Staff Report

To: Salt Lake City Planning Commission
From: John Anderson, 801-535-7214, john.anderson@slcgov.com
Date: August 24, 2016
Re: PLNSUB2016-00511 & PLNPCM2015-00847 Sugarmont Apartments Planned Development and Conditional Building and Site Design Review

Planned Development & Conditional Building and Site Design Review

PREVIOUS ALLEY DESIGN CONCEPT

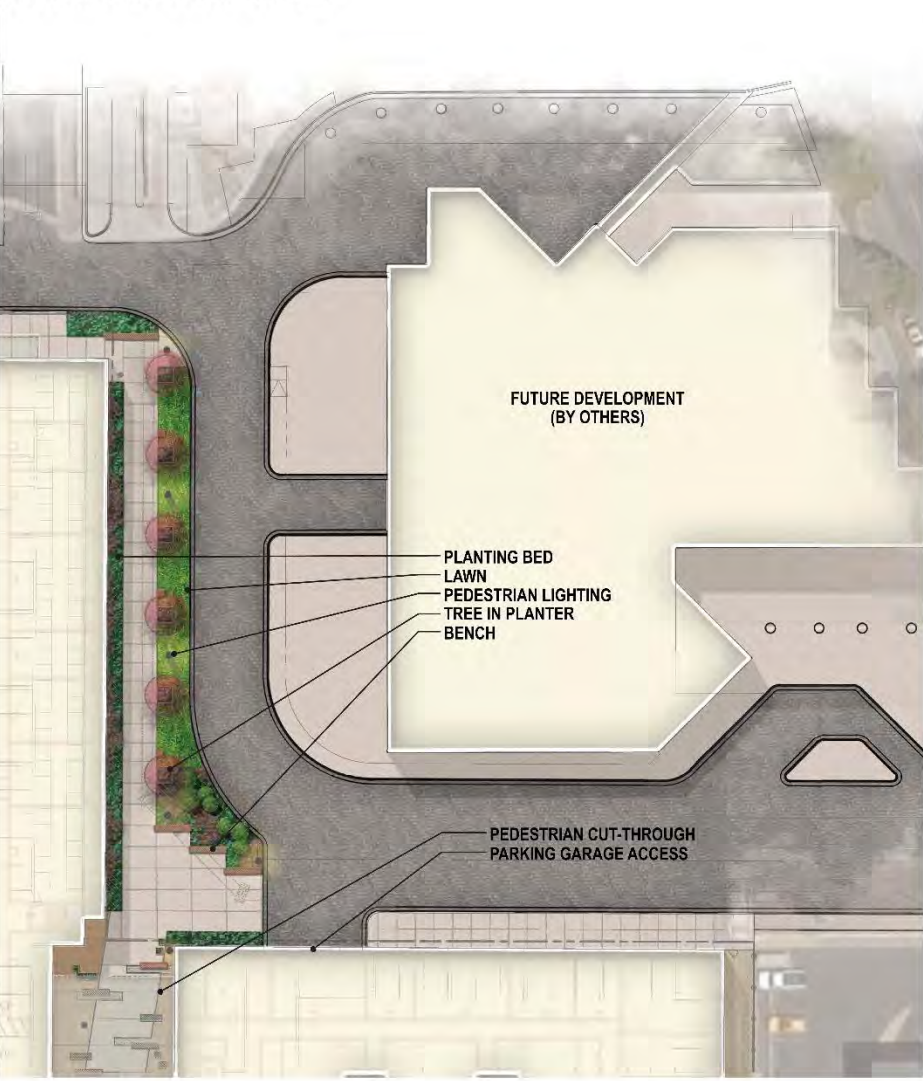
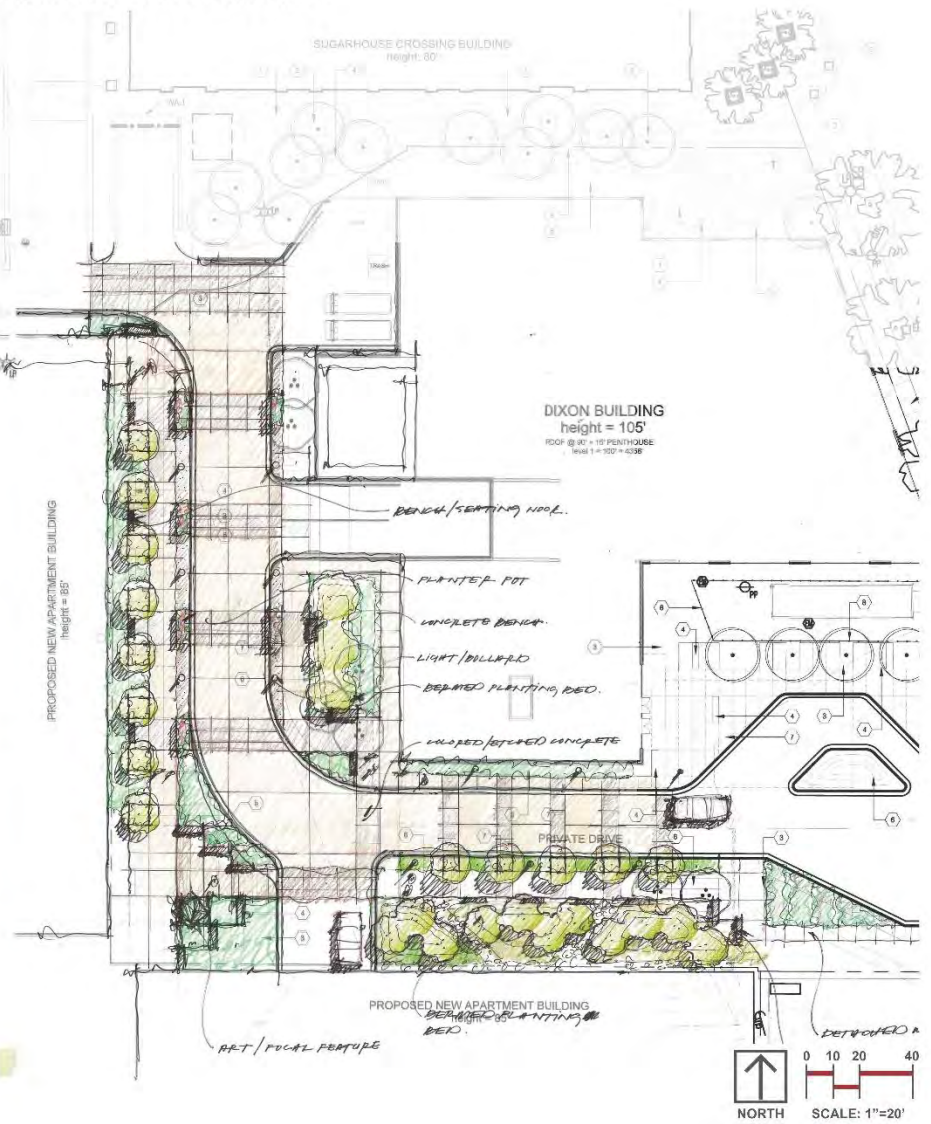
Comment: The project's front entrance appears to meet this standard but it is not clear how pedestrians would access the project on other building facades. It is also not clear how pedestrians would travel through the block itself. Please ensure that pedestrian walkways match those identified in the Sugar House Circulation Plan.

A Pedestrian Passage has been added through the project, connecting the streetcar stop to new and existing pedestrian paths throughout the Granite Block. From the Plaza at the southwest corner of the site, pedestrians will have access to Highlands at two points, and to Monument Plaza and 2100 South.

1 SITE ELECTRICAL PLAN
Scale: 1" = 30'

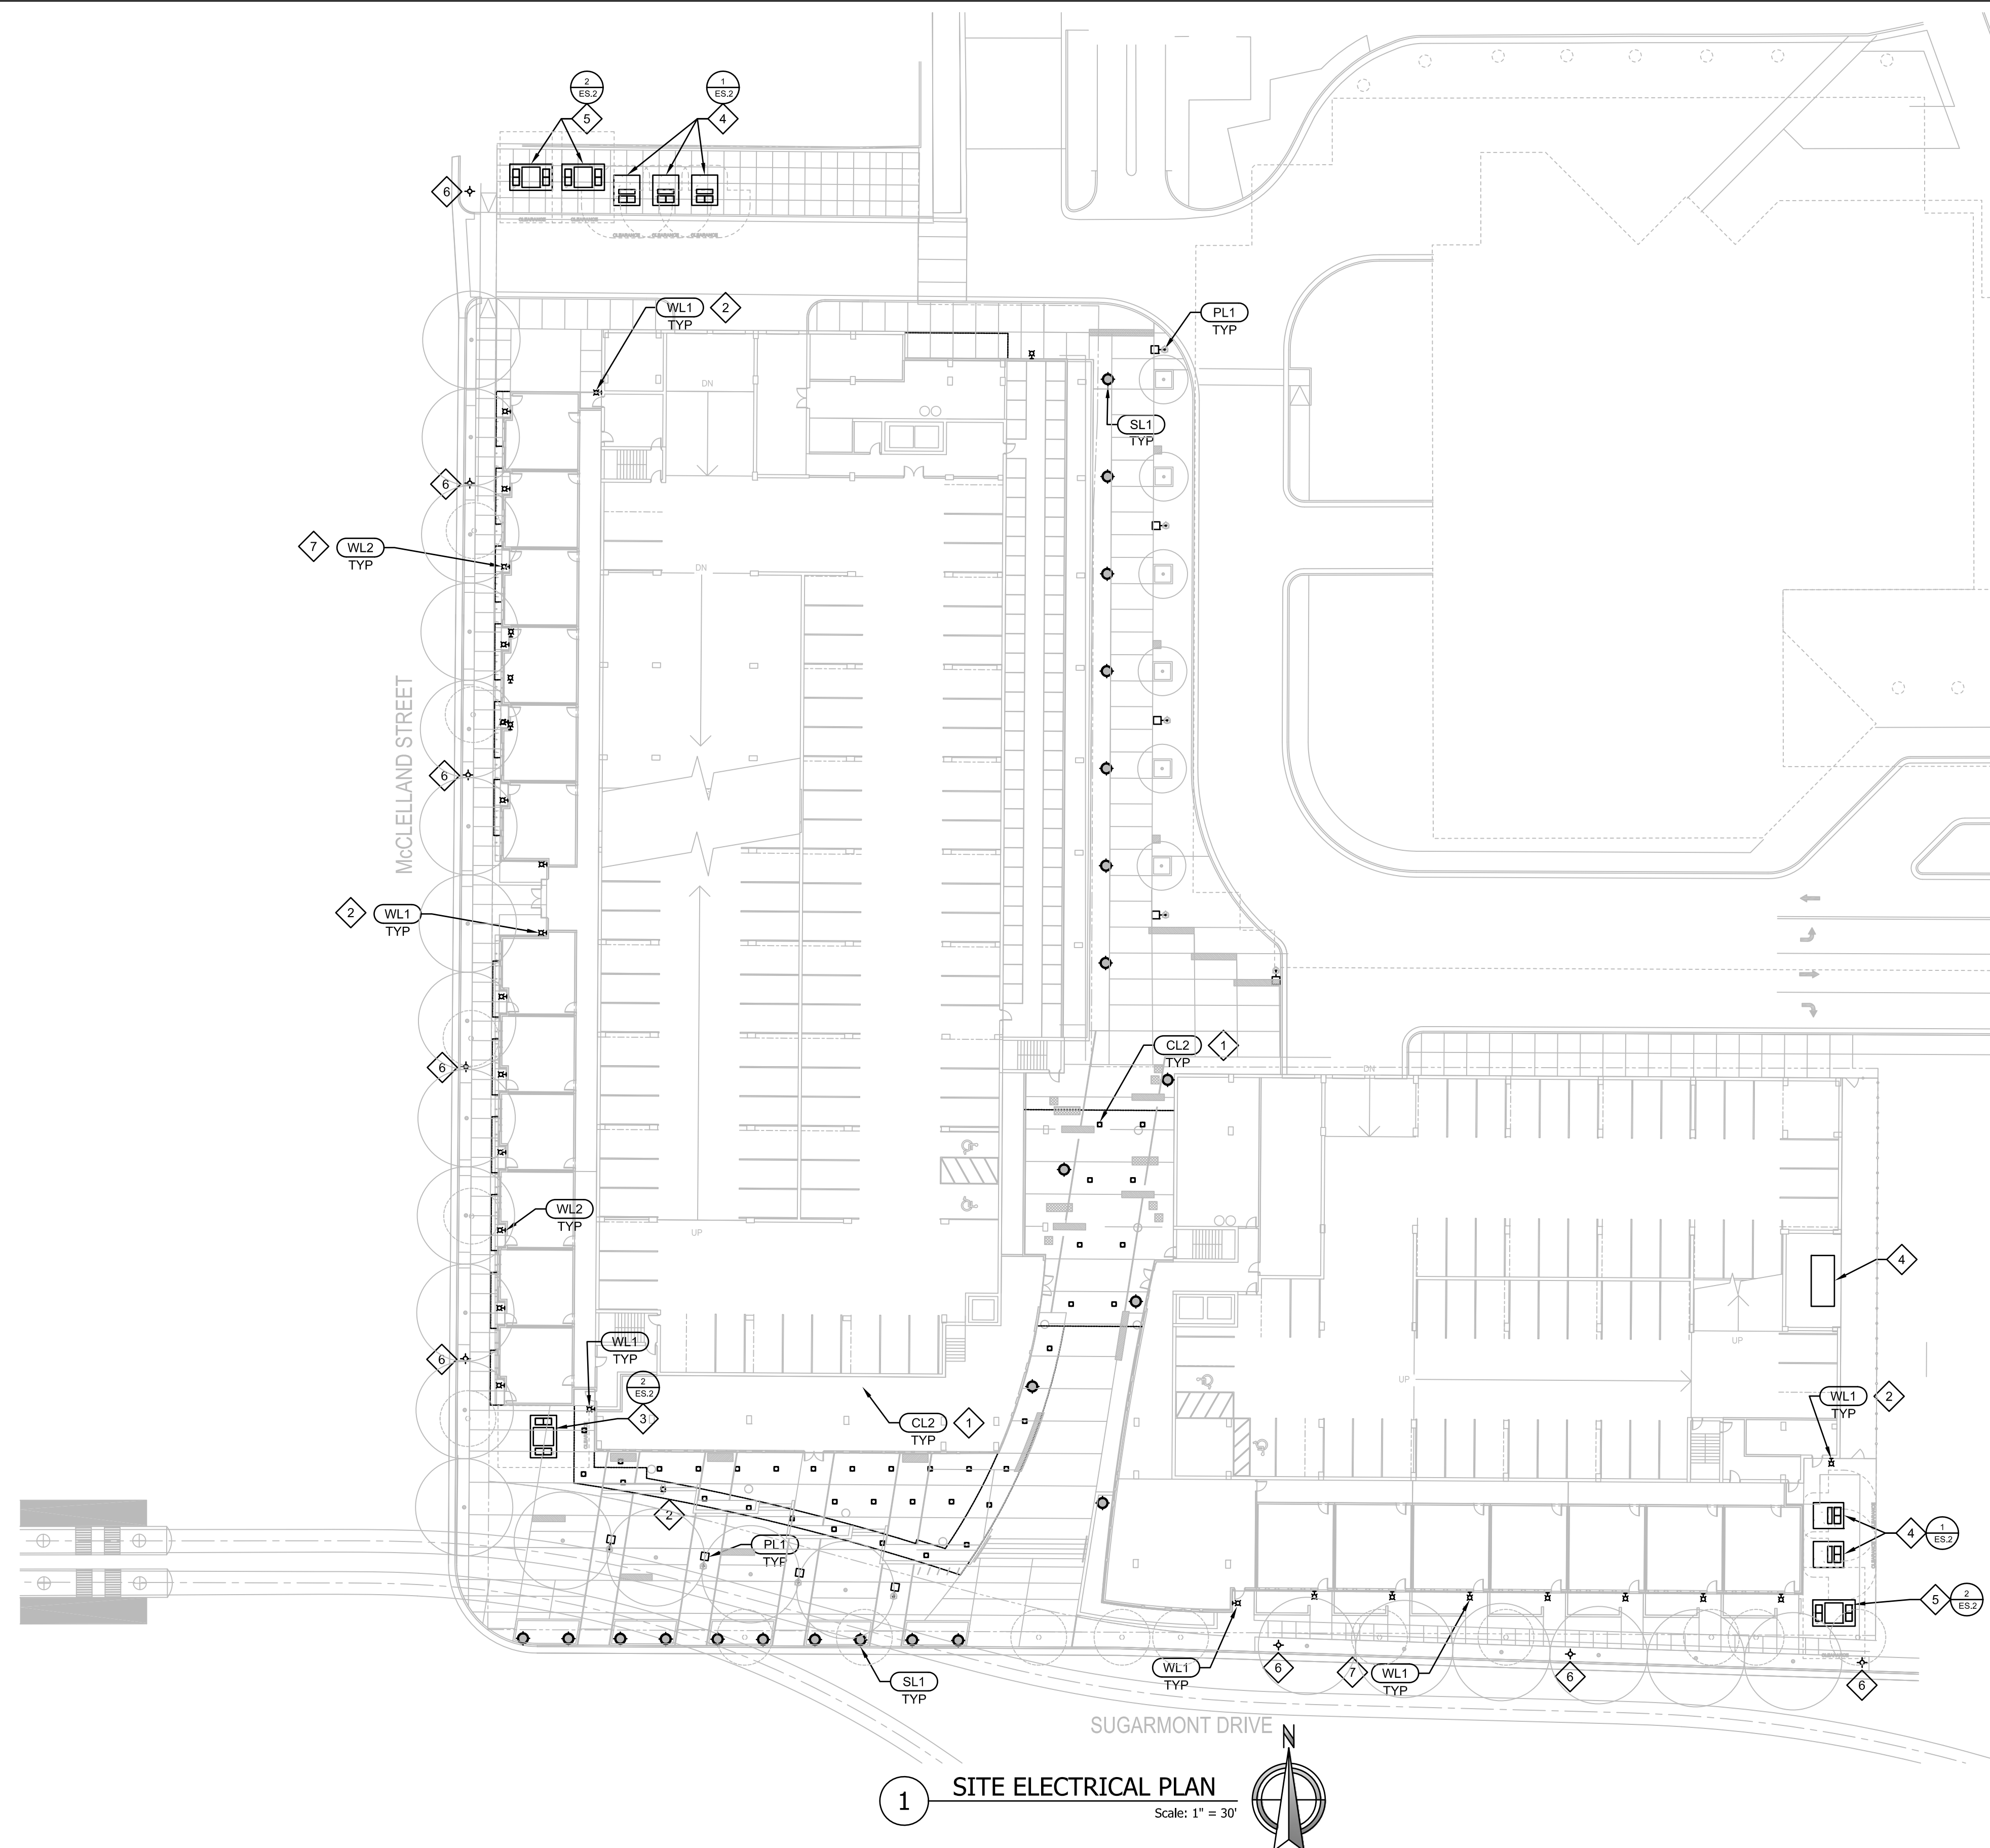
Comment: A lighting plan has not been submitted.

Response: *Please see attached lighting plan. Salt Lake City standard street lights to match existing fixtures located directly to the north at the recently developed areas have been shown at approximately 90' intervals on both McClelland and Sugarmont. Final locations will be coordinated with the final design and submitted at time of permit. Proposed fixtures shall meet all the requirements of the Master Plan. Photometric analysis will be provided with the final permit drawings.*

EXISTING ELEVATION ALONG McCLELLAND ST
 0 8' 16' 32'

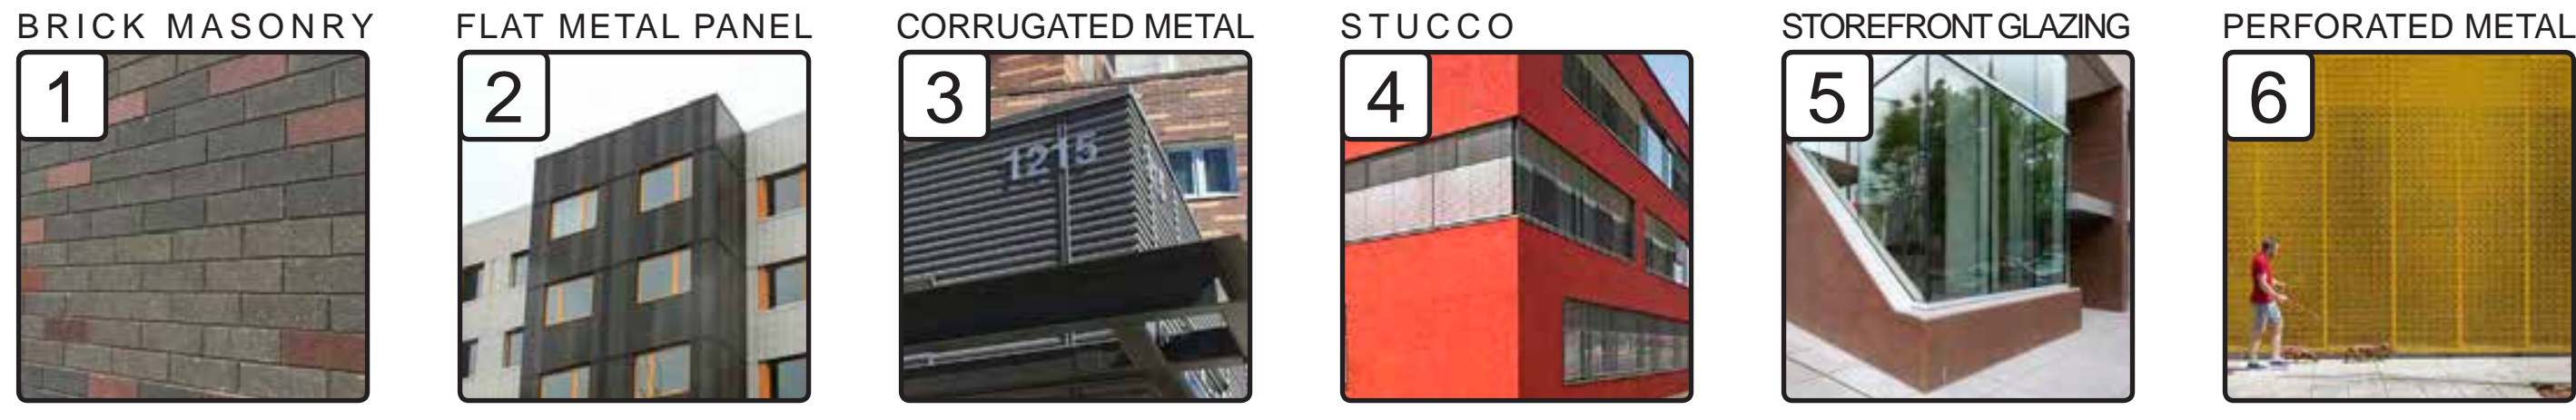
Comment: Height – The elevations show the top of the building at 100 feet in height but then clearly shows additional building height above that mark. Is this a parapet wall and if so what is the height and purpose of such wall? What is the proposed finished height of the structure?

Response: *The height of the building varies, depending on the height of grade around the building. At grade's lowest point, the building height to roof deck is 87'-0". A 3'-0" – 5'-0" tall parapet wall to screen roof-top mounted condensing units and other mechanical equipment is utilized around the building's perimeter.*

EAST FACE ELEVATION

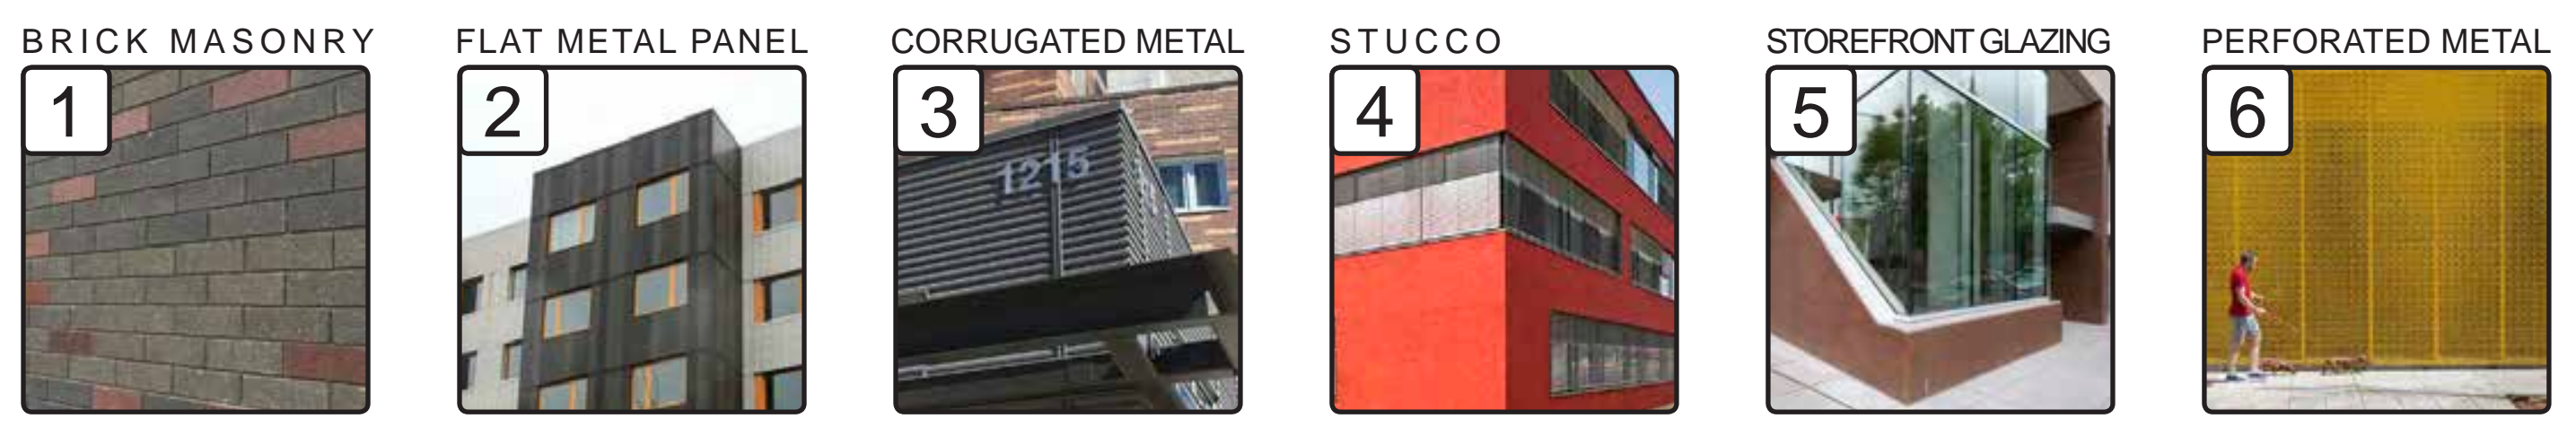
Comment: There is no surface parking proposed. Please provide an improved elevation of the north sides of the proposed structure. The submitted elevation does not provide sufficient detail showing exactly what the parking garage areas will look like. Provide more information about the glazing/glass that will cover the parking garage area. Will this area be completely contained or are there openings?

Response: *Elevations and sections have been provided for the northern and eastern facades of the garage in the east leg of the building. The garage in the north leg of the building is completely wrapped by units and is not visible to public view. The exposed areas of the garage incorporate perforated metal screening panels. All openings within the facade of the garage that do not show metal panel screening are not glazed. Care shall be taken to minimize and shield the lighting within the garage to comply with City standards for lighting. Material callouts and images are shown and labelled on building elevations.*
